CONSTRUCTION GENERAL PERMIT SITE INSPECTION REPORT - LEVEL 1 (FOCUSED)

Project Name:		Scott Solar project			Permit Number:					Var10i027	
Project Address:		37.53 long 77.94			County/City:					Powhatan	
Project Operator:		VA Electric and Power Co			Operator Telephone:					804-380-6362	
Project Contact:		Robert Smith Rob.smith@dom.com			Contact Telephone:					David Clarke 770-815-6834	
Contact E-Mail:		Scott.lawton@dom.com			Qualified Personnel (QP):					David Clarke	
Inspector:		Matthew Grant			Weather (Wet/Dry/Rain):					Dry	
Dist	urbed Acreage:	155			Inspection Date & Time:					10-26-16 9:15	
Line	ar Project:	Yes 🔀 No	Annual Stands	. & Specs:	☐Yes ☒ No VSMP Authority: ☐Locality ☒ DEQ						
Stag	e of Constructio	n:									
	Initial Clearing & 0	Grading Rough Grading			☐ Building Construction ☐ Final Grading						
	Construction of S\	VM Facilities	Notice of Termination S Other: solar panel install								
	re of Project:		-					Re-Inspection:			
	Public X	Private	Other					⊠ Yes □No

CONSTRUCTION GENERAL PERMIT SITE INSPECTION REPORT REQUEST FOR CORRECTIVE ACTION

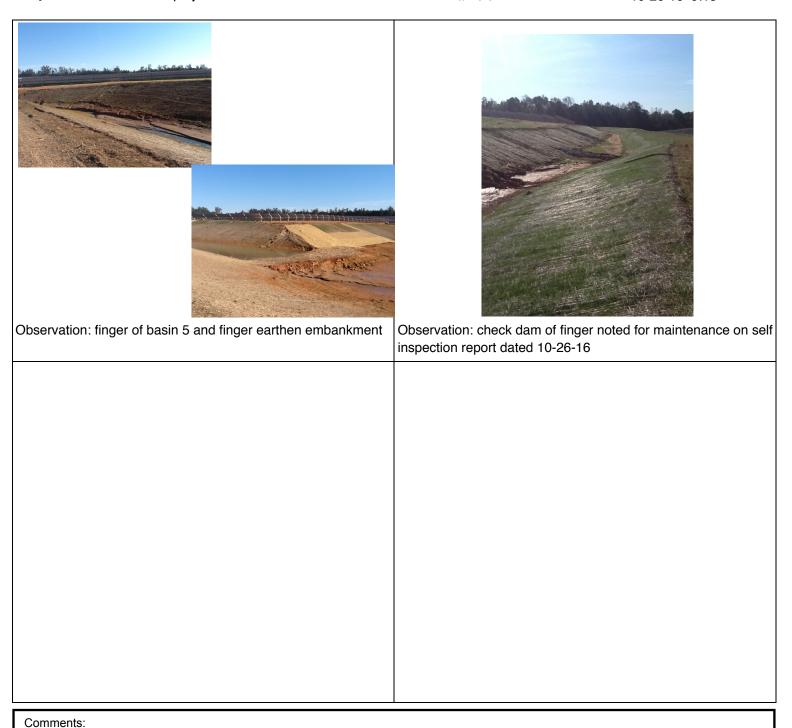
Continue to stabilize and repair erosion
